MANUAL CHANGES

Model Number: 8690B
 Date Printed: May 1972
 Part Number: 08690-90018

This supplement contains important information for correcting manual errors and for adapting the manual to instruments containing improvements made after the printing of the manual.

▶ Page 7-3, Figure 7-2:

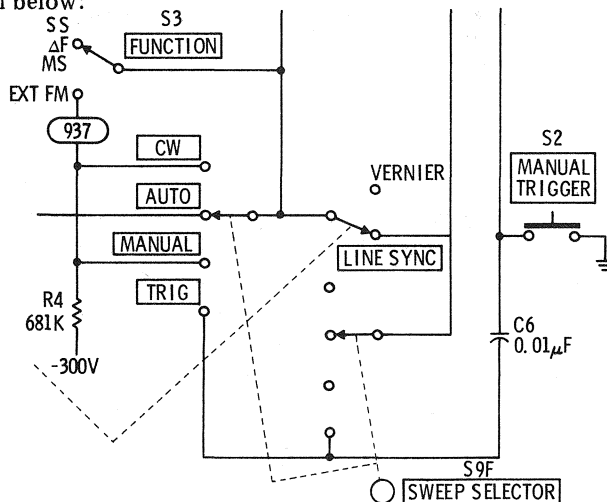
Change switch labeling as shown below:

P/O Figure 7-3. Frequency Control Section Reciprocal Amplifier

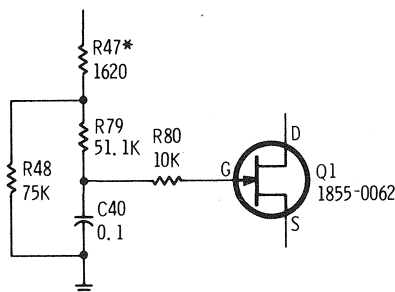
Change the circuitry of A3Q1 as shown in the attached drawing:

Component Identification, Assembly A9

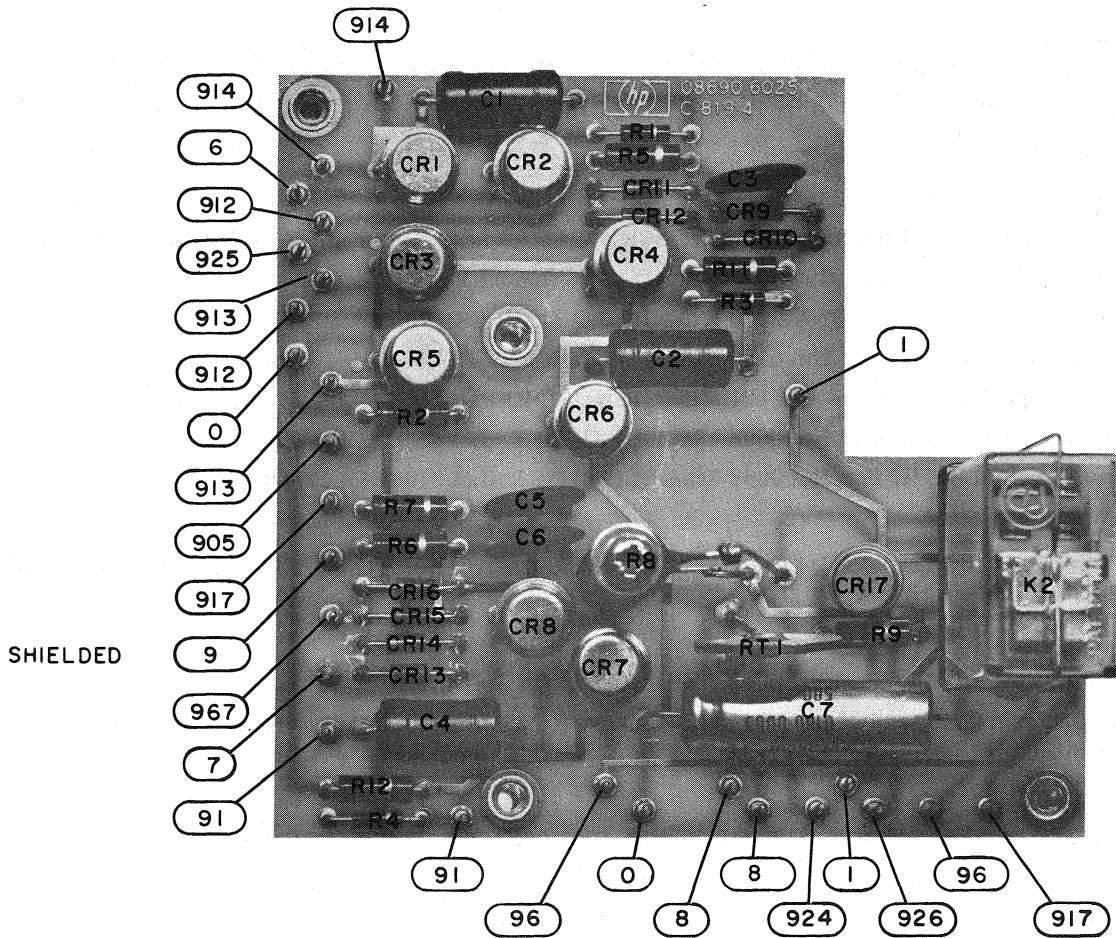
Substitute the attached A9 Component Identification board for that shown in the 8690B Manual.

Figure 1. Component Identification, Assembly A8 (Part of Change 1)

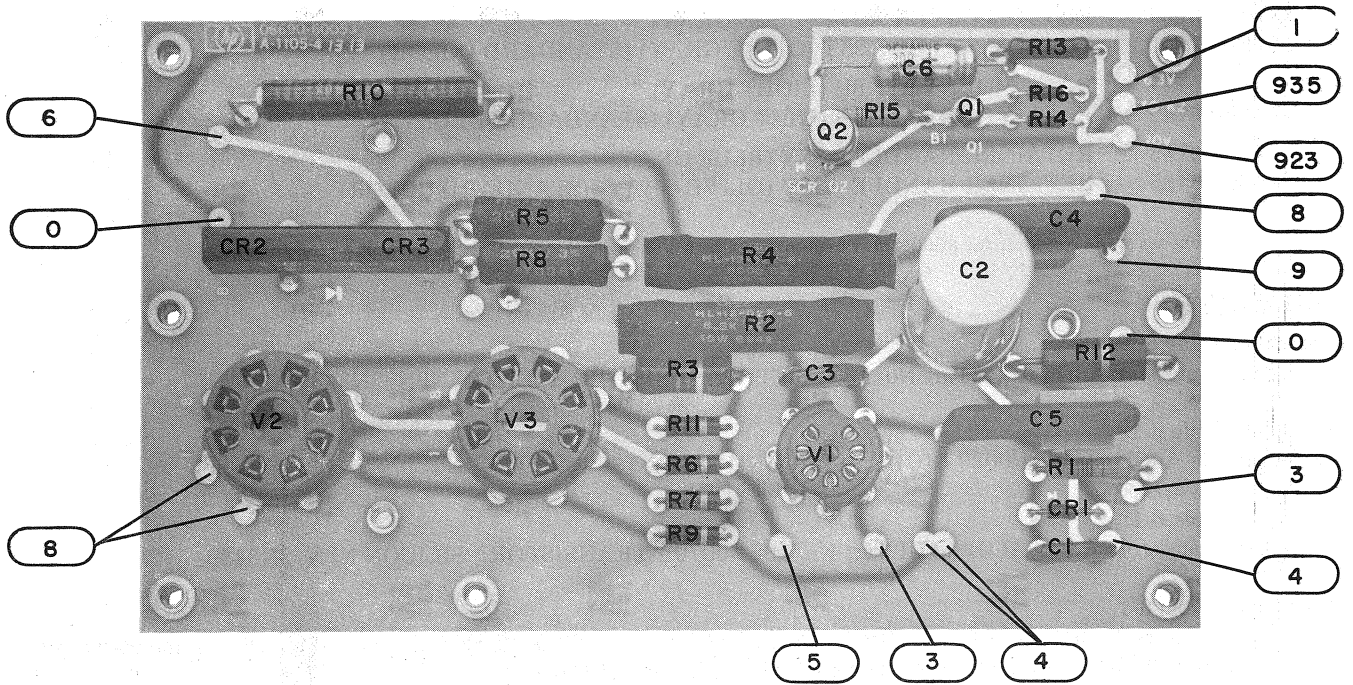
Substitute the attached A8 Assy, Component Identification board photo (Figure 1) for the photo shown in the 8690B Manual.

Figure 2. Component Identification, Assembly A14 (Part of Change 2)

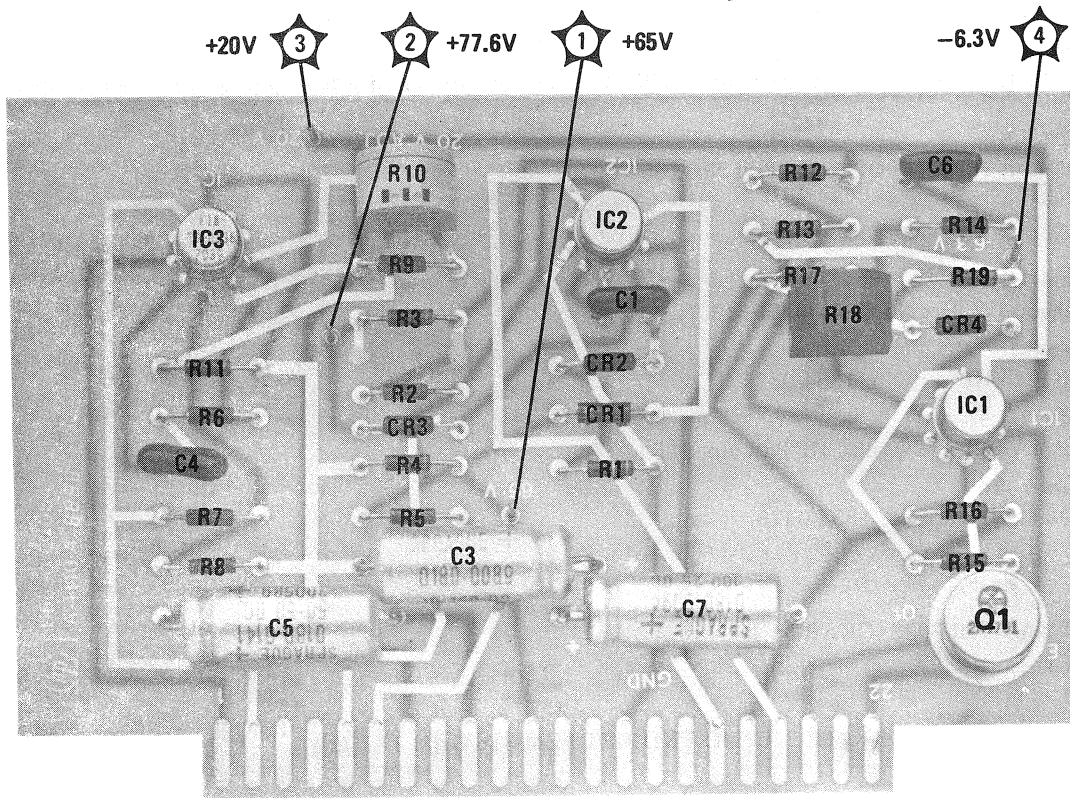
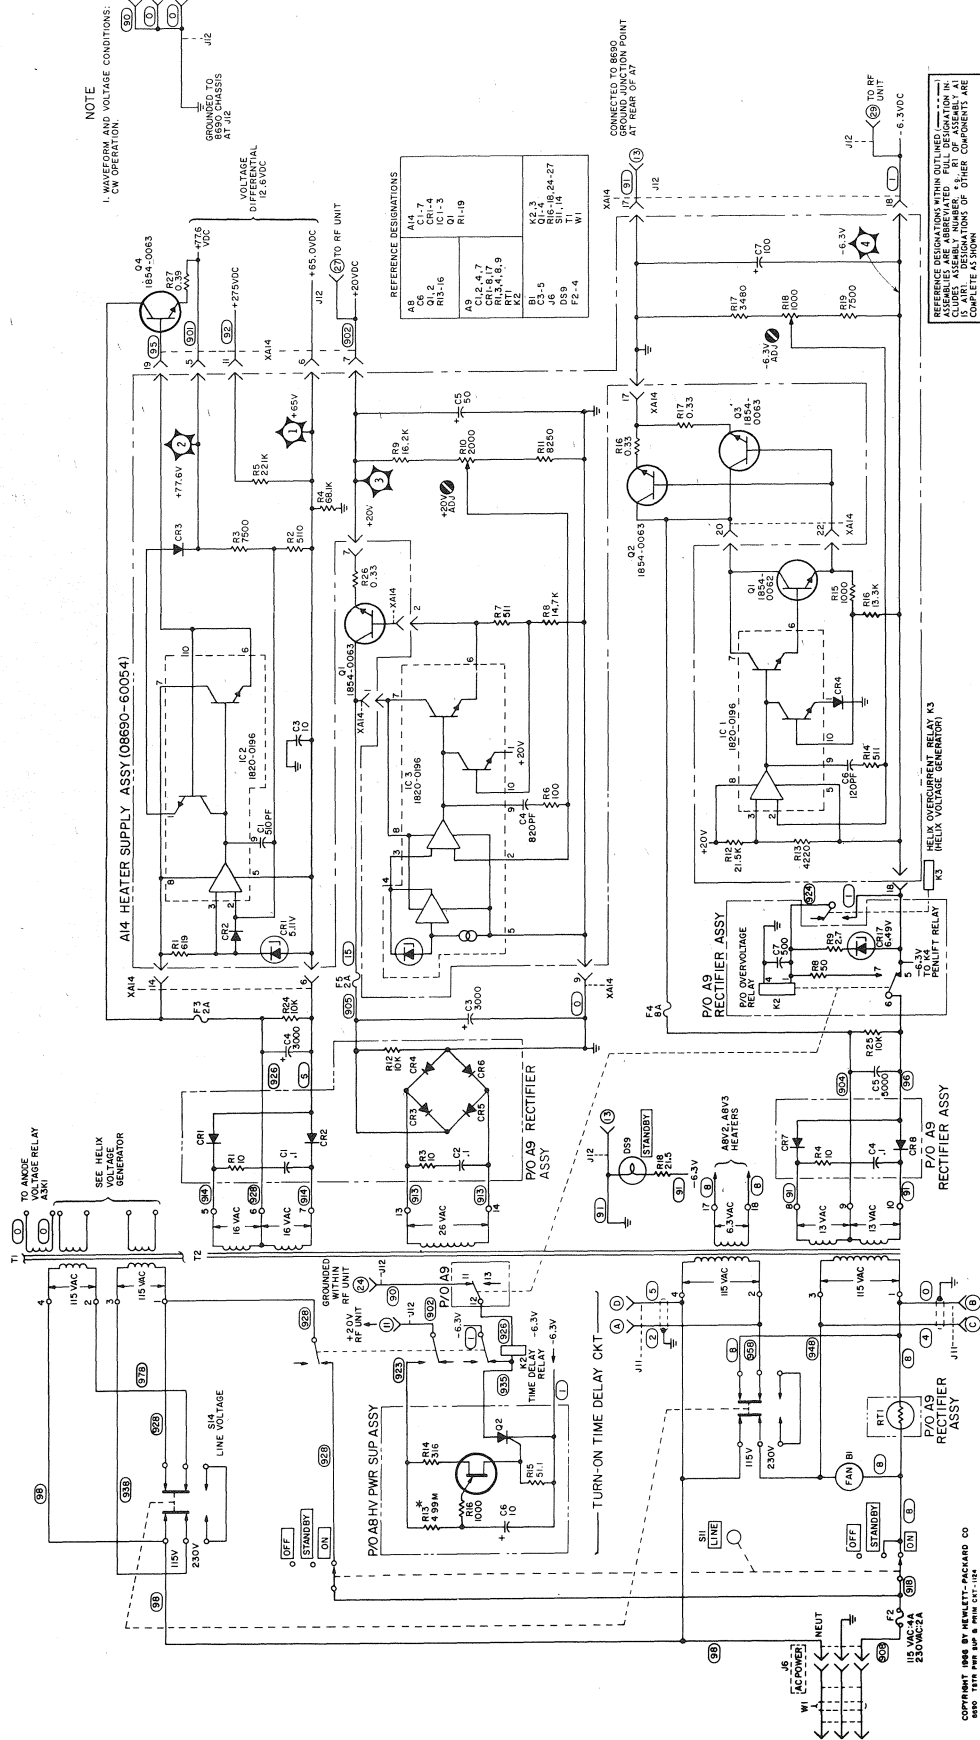
Substitute the attached A14 Assy board photo and schematic (Figures 2 and 3) for those shown in the 8690B Manual.

Figure 4. Component Identification, Assembly A4 (Part of Change 5)

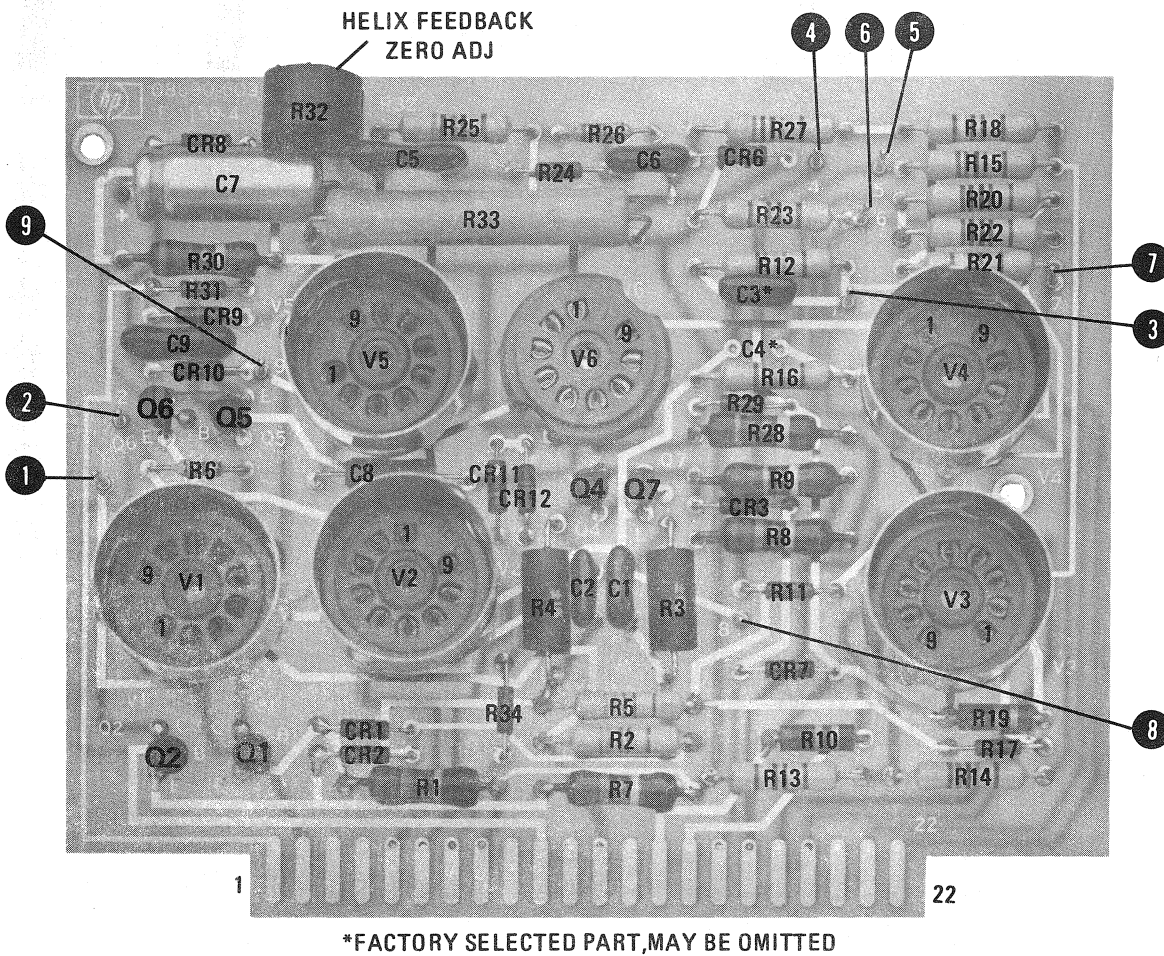
Add diode A4CR12 in series with zener diode A4CR11. Connect cathode of A4CR12 to ground, and anode to A4CR11.

Figure 5. Component Identification, Assembly A3 (Part of Change 1)

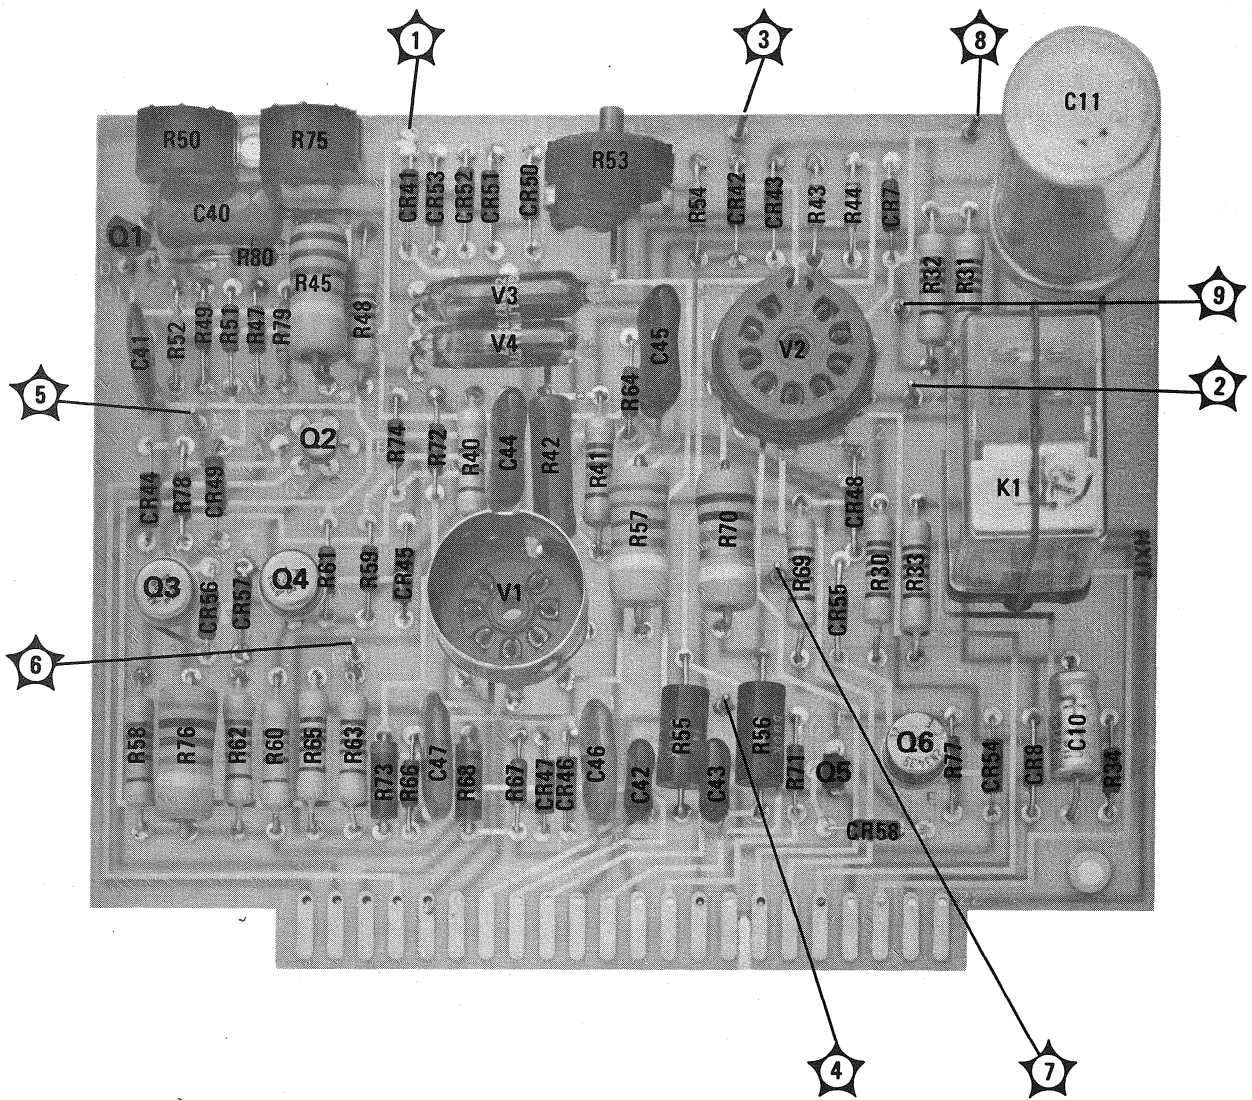
Substitute the attached Component Identification Assembly A3 board photo (Figure 5) for the photo shown in the manual.

Figure 6. Partial Schematic Diagram of the Power Supply Section Showing Thermal Switch S15 (Part of Change 11)

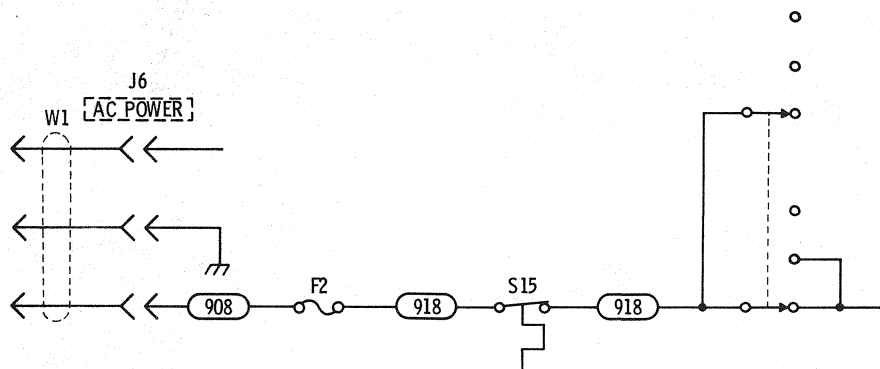
Add thermal switch S15 to schematic diagram of Power Supply Section as shown in Figure 6.
